**TOWN OF HERNDON, VIRGINIA
ARCHITECTURAL REVIEW BOARD
WORK SESSION AGENDA
AUGUST 5, 2020
HERNDON COUNCIL CHAMBERS BUILDING
765 LYNN STREET
7:30 P.M.**

MEMORANDUM

Subject: August 2020 ARB Work Session Case Update, ARB #20-017 1106 Herndon Parkway

Subject: Discussion Item – Fairbrook Development Plan Building and Landscape Architecture Review

Proposed Sign

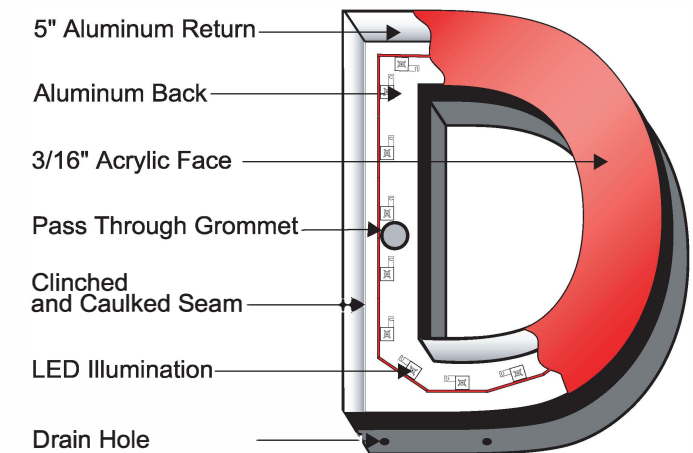
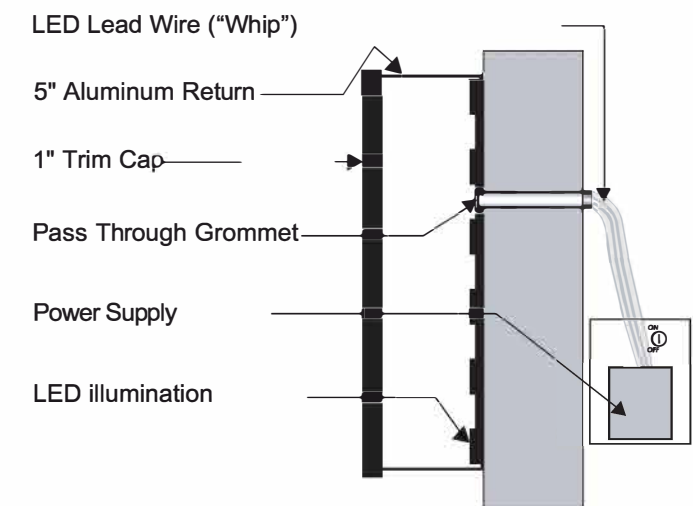
Since the work session, the applicant has submitted a revised design that addresses the zoning compliance issue by removing the cabinet sign features, specifically the logo and "& Sushi" cabinets, as well as removing all exposed raceway transformers. All letters are now proposed to be flush mounted to the exterior fascia of the sign panel and internally illuminated. The "& Sushi" is now proposed to be 9" tall, 5" deep channel letters with 1" trim caps and a translucent faces with translucent vinyl coverings so that this sign component illuminates red at night and appears red during the day as the rest of the sign.

However, staff finds that the revisions do not address the previous design issue raised by the Board, namely the design of the “E”. Staff has also determined that if the “E” design is a corporate or business identity component, then it is recommended that the Board be aware of a pre-existing corporate identity already established by the business.

- 1) The sign design and installation will be in substantial conformance with the revised submission materials, including revised elevations and sign details, submitted by the applicant on or about July 31, 2020.**

Proposed Sign Location

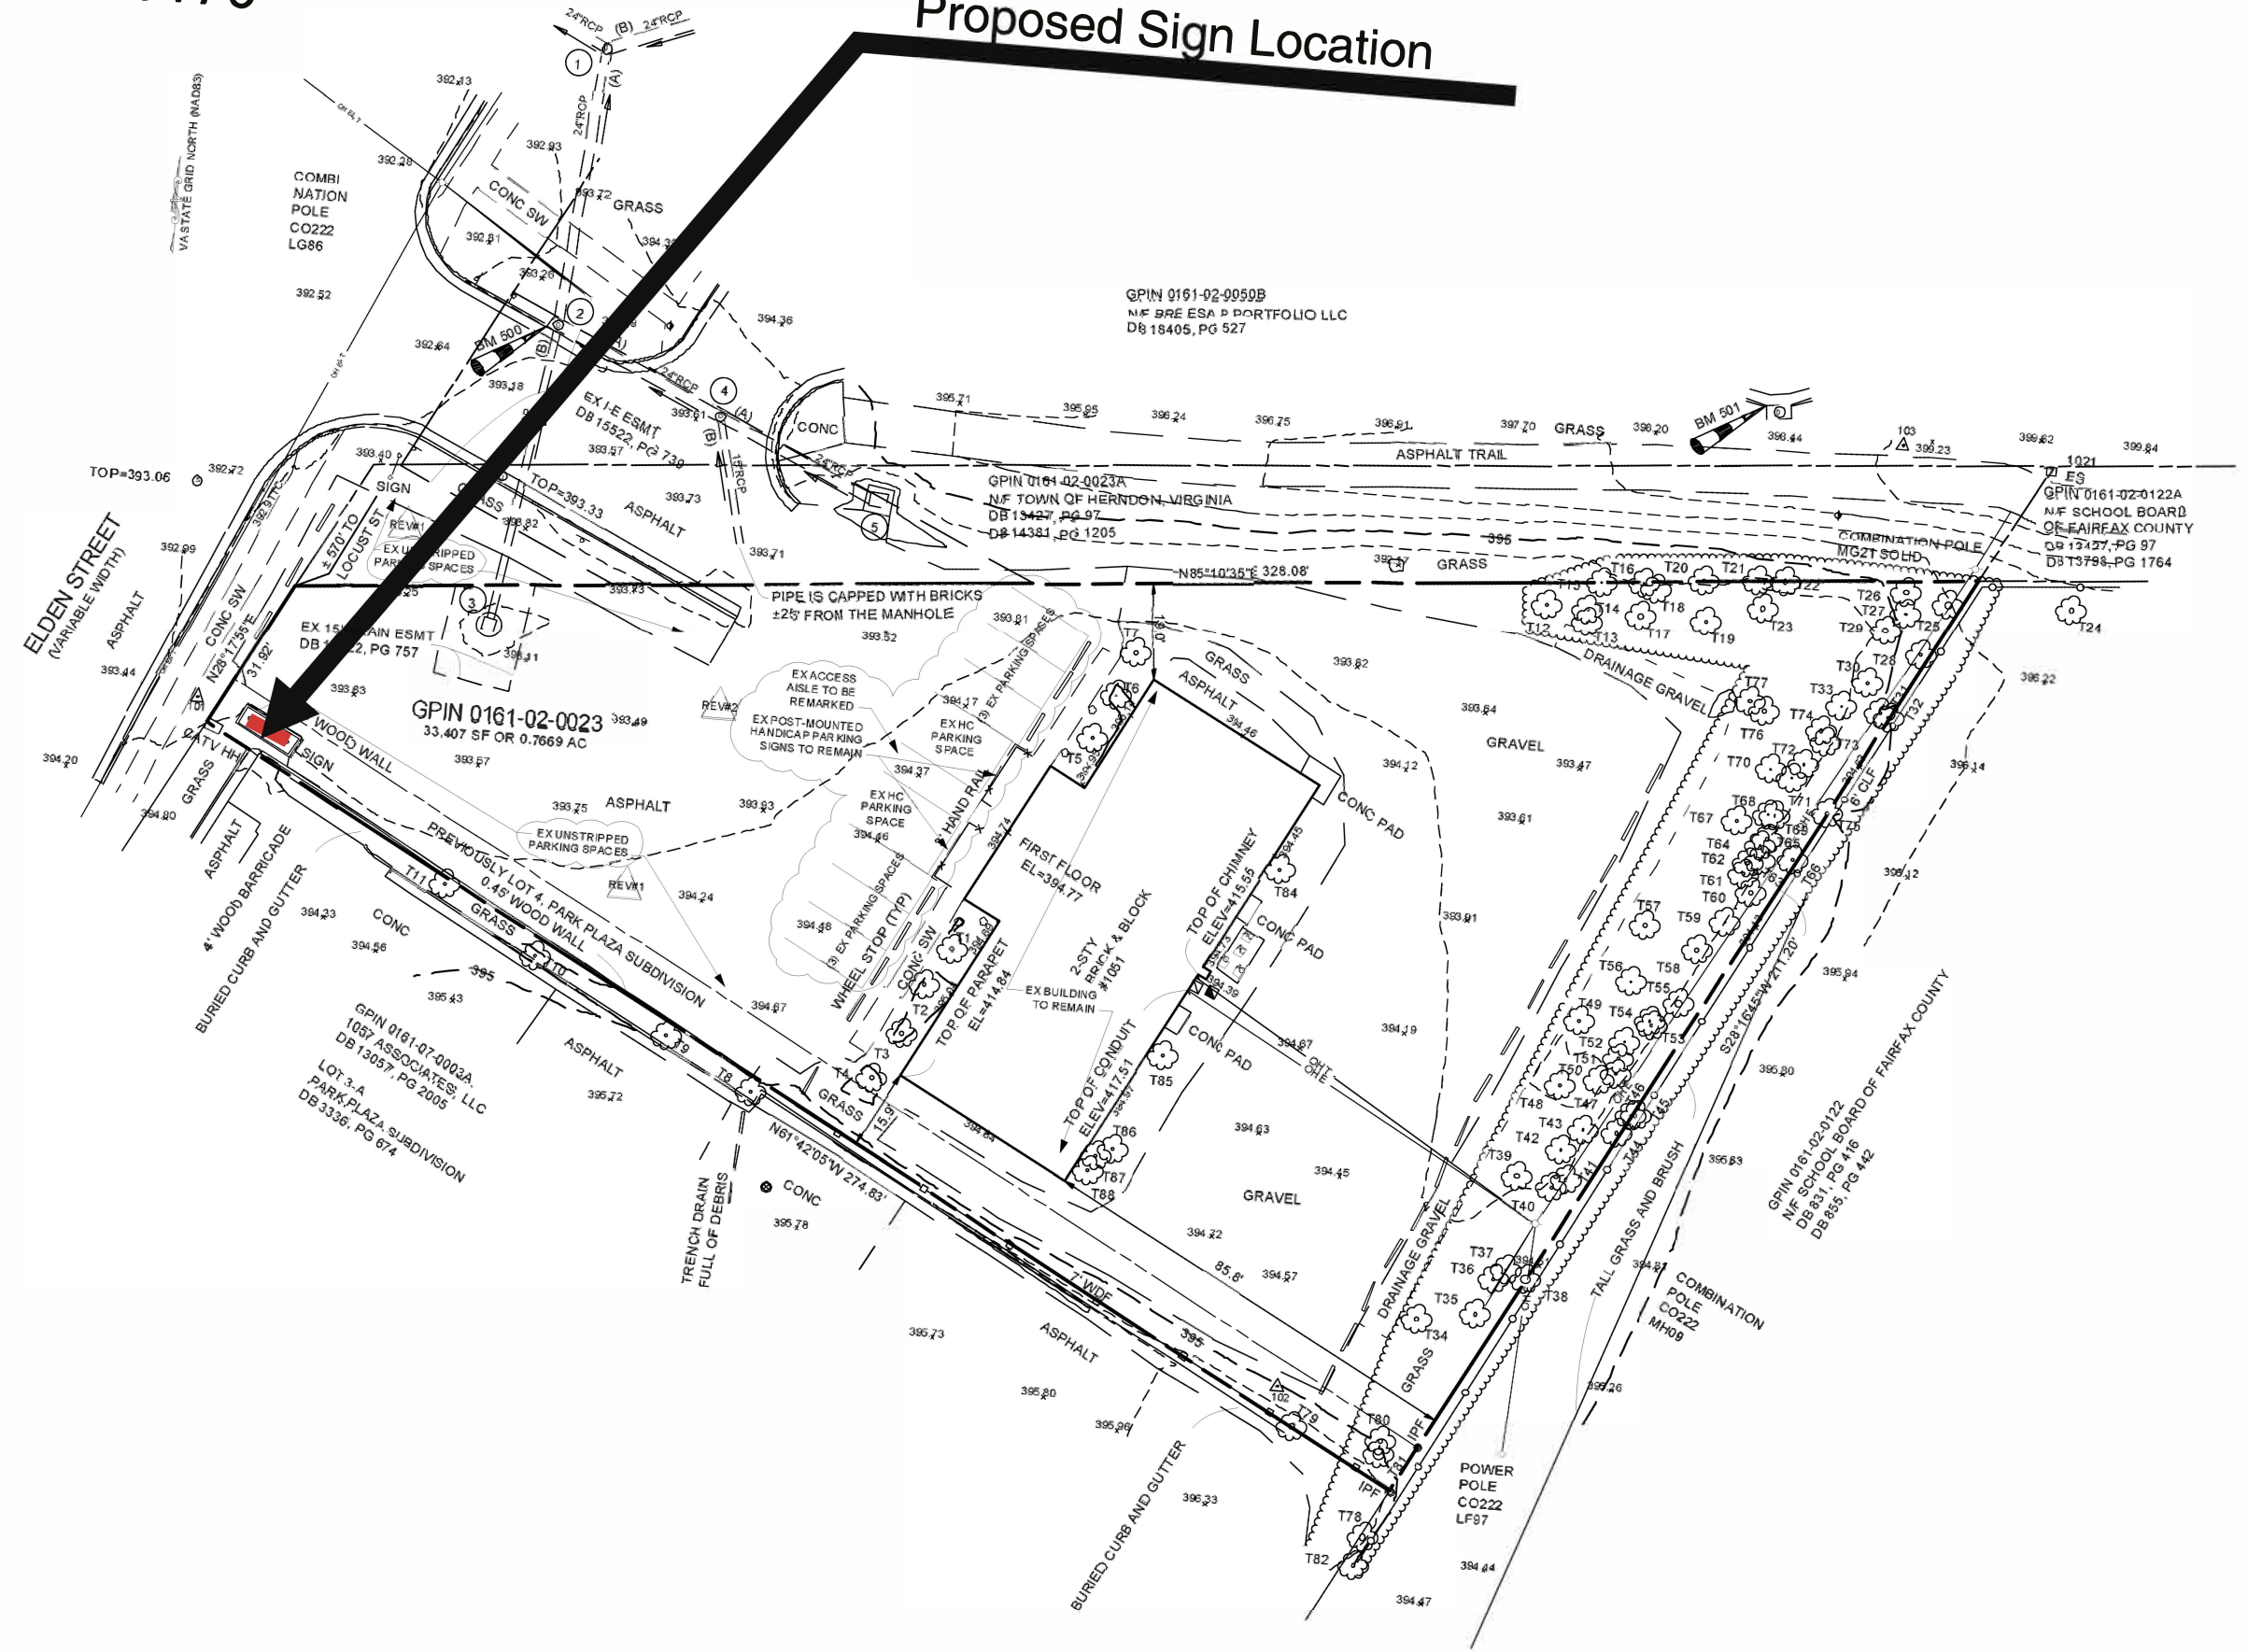
2. The proposed sign meets the Town Zoning Ordinance, Section 78-140.6. - *General standards for all signs* regarding, the sign types, design, placement, and illumination. However, the site plan does not clearly specify the distance from the adjacent right-of-way (ROW). Section 78-140.6 and Section 78-141.4 specify a minimum of 5' from adjacent ROW. This needs to be verified with an updated site plan noting the distance from existing ROW along Elden Street. In addition, Section 78-140.6 specifies a landscaped area 4' around the sign in all directions, which is not specified in the submission and may not be feasible based on the currently proposed sign location, at 2' away from an adjacent property line. Staff finds that this design submission is not compliant with the referenced zoning ordinance section and staff's review is partially inconclusive due to missing information. While the Board may wish to discuss other aspects of this sign design at the work session, the Board may not consider action on this case until these zoning compliance issues are resolved.

Front and Back View

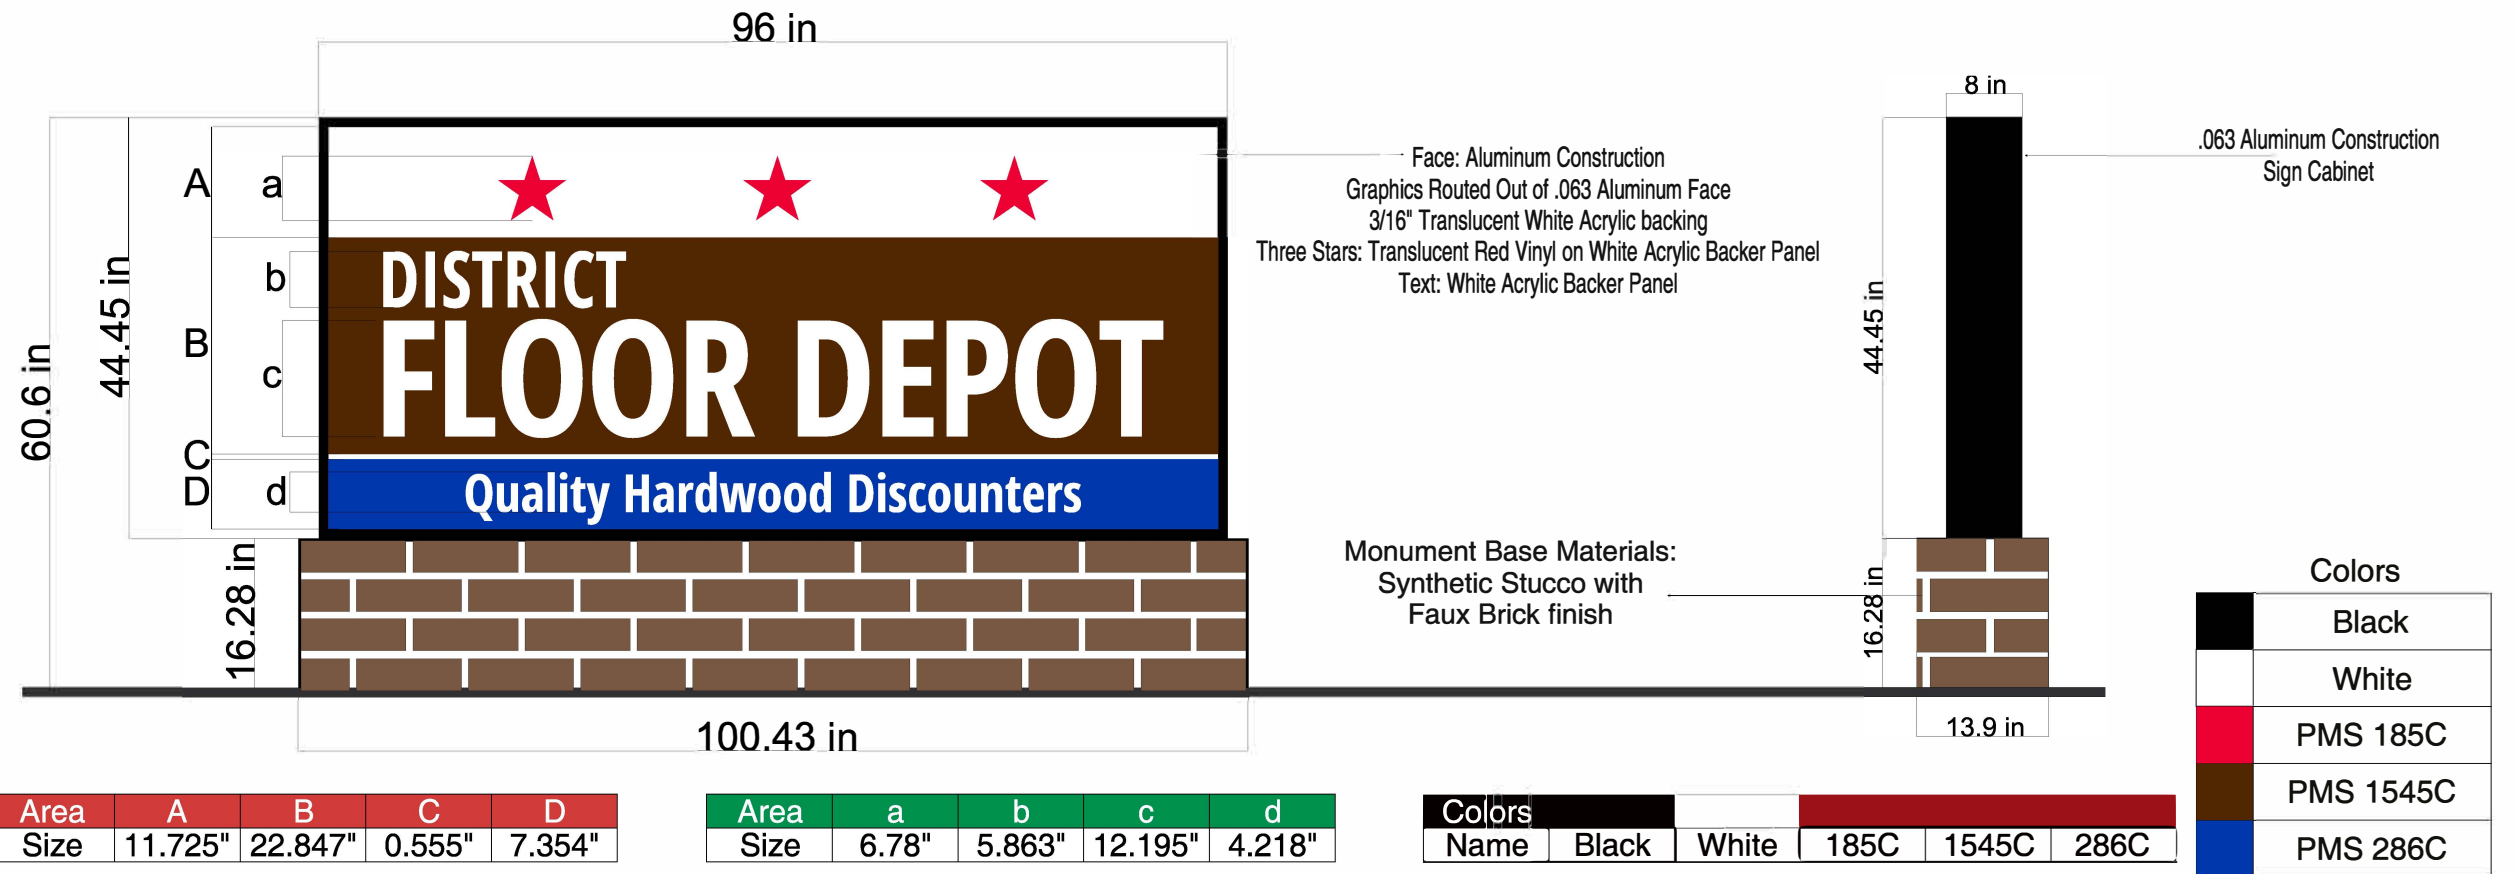
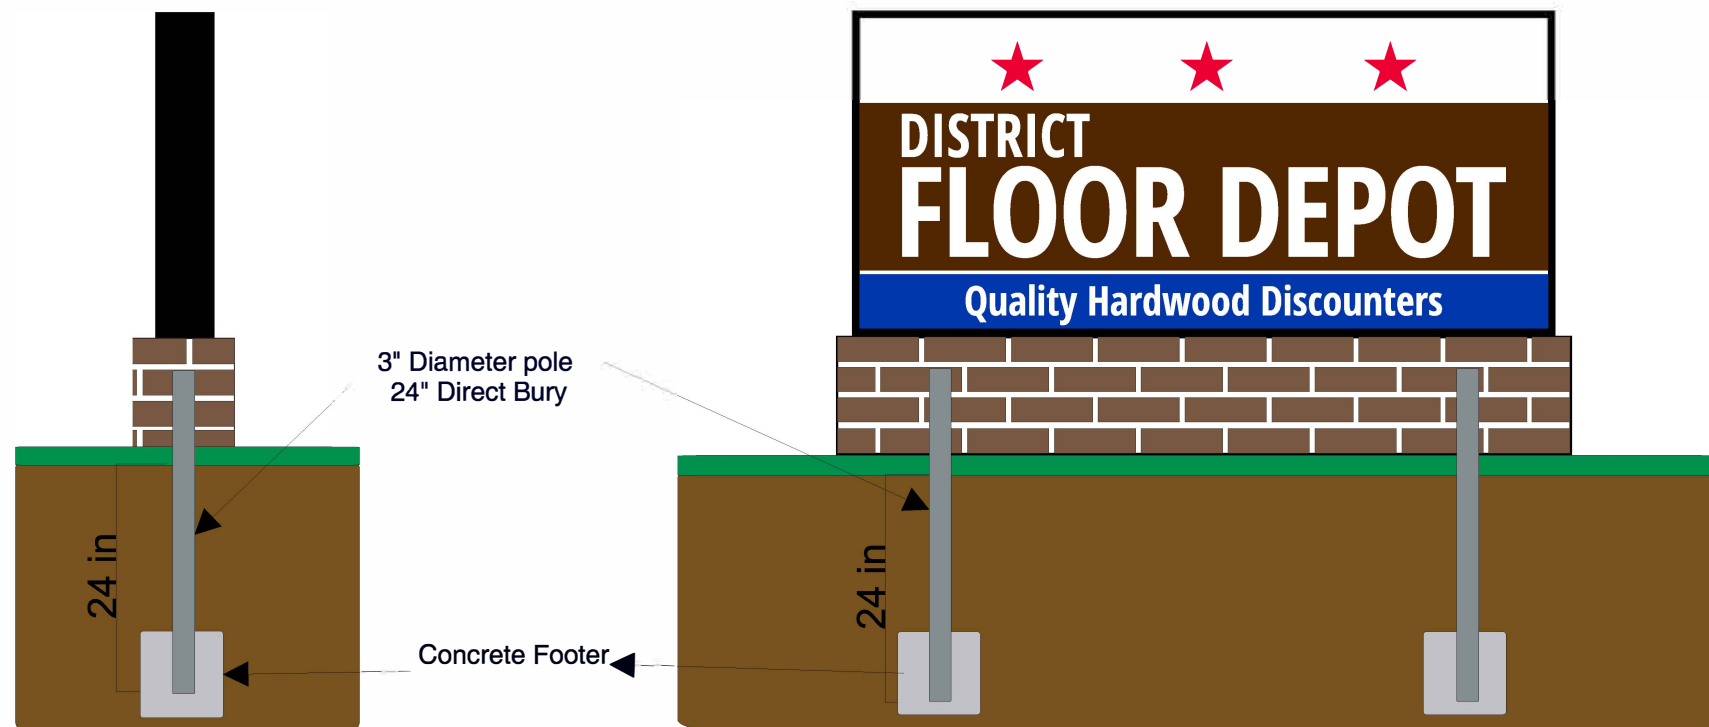
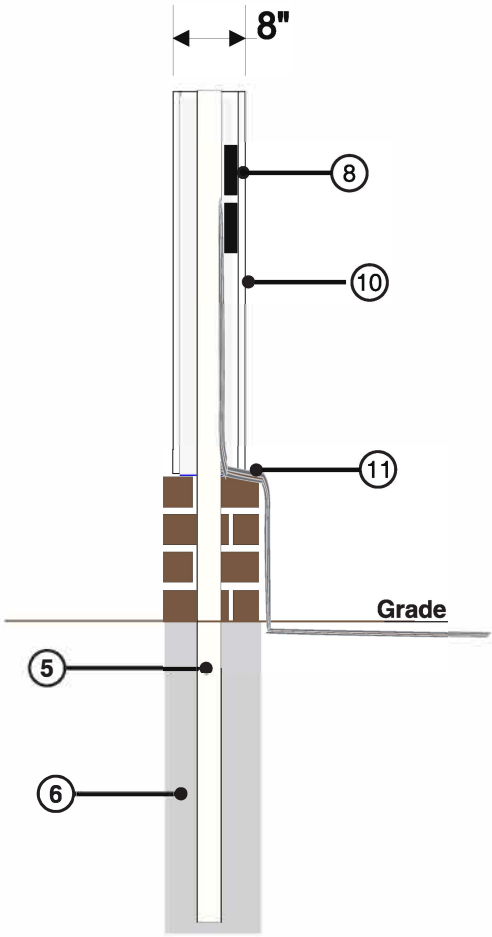
3. Staff has several concerns and questions related to the materials, assembly and compatibility of this new proposed sign, which include:
 - a. The submission materials show two different internal structural configurations which needs to be clarified, specifically the two internal structural poles which support the sign base and sign face form(s).

- b. The Polystyrene structural core and exterior coating is atypical of freestanding sign bases previously considered by the Board. Staff has substantial concerns about the stability and durability of this system. Typically, staff and this Board have reviewed

- c. The painted *faux* brick finish does not appear to attempt to match the design, texture, materials and colors of the commercial structure on the site. One note in the submission also states that a synthetic stucco finish will be applied to the sign base. In either case, staff does not find this compatible with the commercial structure's architecture and brick exterior.

- d. The method of how the color fields of the aluminum sign panels will be applied is not clear in any details or notes in the submission materials. This needs to be clarified in updated submission materials.

- e. The submission details indicate that the power supply is through a rudimentary exposed electrical conduit that is to be somehow attached to the exterior sign base. Staff has questions as to why this exposed electrical conduit cannot be run underneath the sign base and upwards through the internal cavity of the sign to power the internal LED light array. The exposed conduit may appear unsightly to the finished product.

- f. The submission materials do not detail how the sign panel will be attached to either the ambiguous internal structure or the sign base.

- Resubmission of application materials that clarify or provide missing sign design details, and
- Revision of the sign base design, materials and assembly to be more complimentary/compatible to the existing buildings architecture.
